Service information

Reference no.: SDA_94868

GC86xx Carry lock tight

Front lock assy
Service code: 423902170783

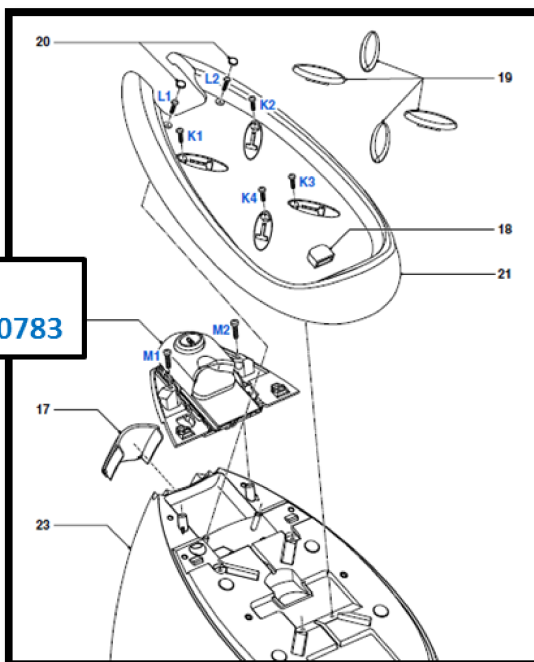
- Carry lock tight after carry lock release button is pressed.
- Carry lock unlock slowly after carry lock release button is pressed.

- Due to less optimal clearance in the carry lock sliding.

- Replace the faulty front lock assy with a new front lock assy (Service code: 2439 021 70783).

- Product corrective action: All GC86xx products with date code > wk1233 will have the improved carry lock installed during production.
